Project	IEEE 802.16 Broadband Wireless Access Working Group < http://ieee802.org/16 >
Title	Addition of Network Exit Procedure in Network Entry Management
Date Submitted	2007-01-18 2
Source(s)	Jee Hyeon Na, ETRI, E-mail: jhna@etri.re.kr Jaesun Cha, ETRI, E-mail : jscha@etri.re.kr JungMo Moon, PhD, ETRI, E-mail: jmmoon@etri.re.kr Mi-Young Yoon, ETRI, E-mail: myyun@etri.re.kr Sang Ho Lee, PhD, ETRI, E-mail: leesh@etri.re.kr Yun Won Chung, PhD, Soongsil University, E-mail: ywchung@ssu.ac.kr
Re:	Call for Comment on P802.16g D6 Document
Abstract	This contribution proposes service primitives for network entry.
Purpose	The document should be considered during the resolution of comments on the D6 document.
Notice	This document has been prepared to assist IEEE 802.16. It is offered as a basis for discussion and is not binding on the contributing individual(s) or organization(s). The material in this document is subject to change in form and content after further study. The contributor(s) reserve(s) the right to add, amend or withdraw material contained herein.

Addition of Network Exit procedure in Network Entry Management

Figure xxx – Network Deregistration Primitives by MS

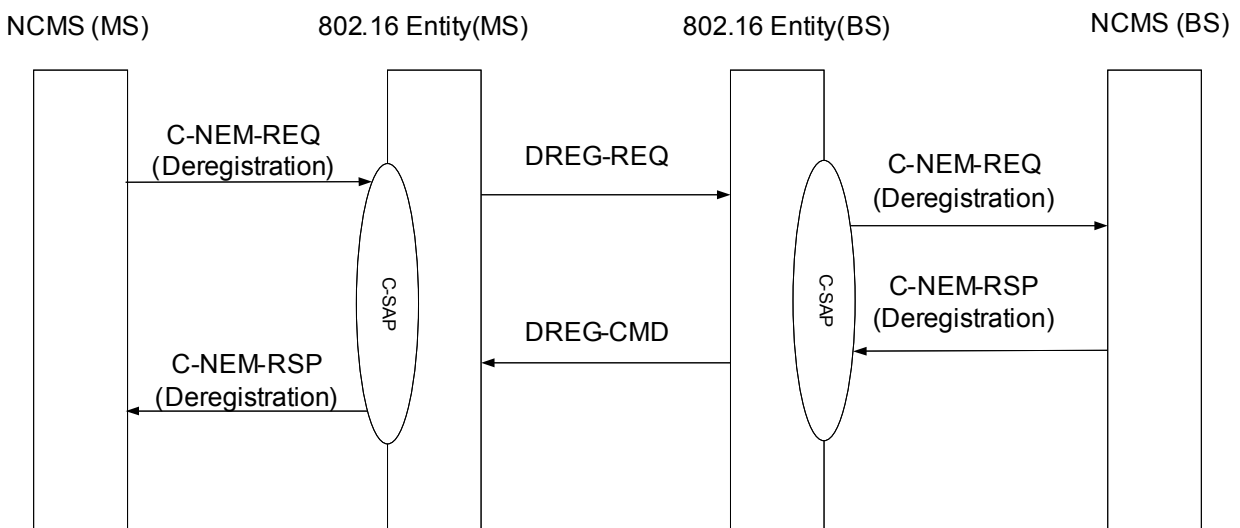
[Inserts the following after figure 500]

Figure 501 – M-TM primitives flow for De-Registration

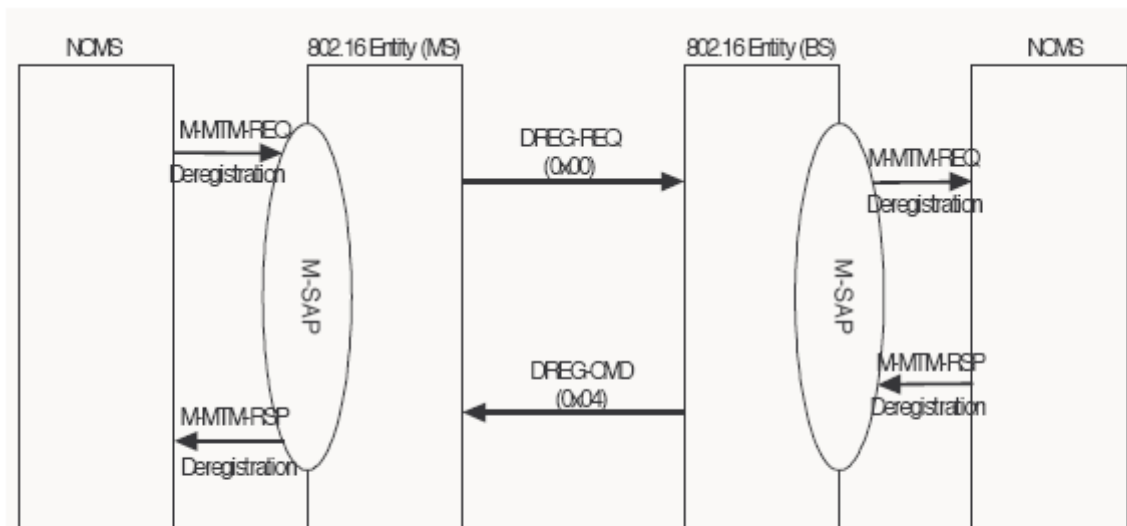
[Delete Figure 501 before 14.2.7.3]
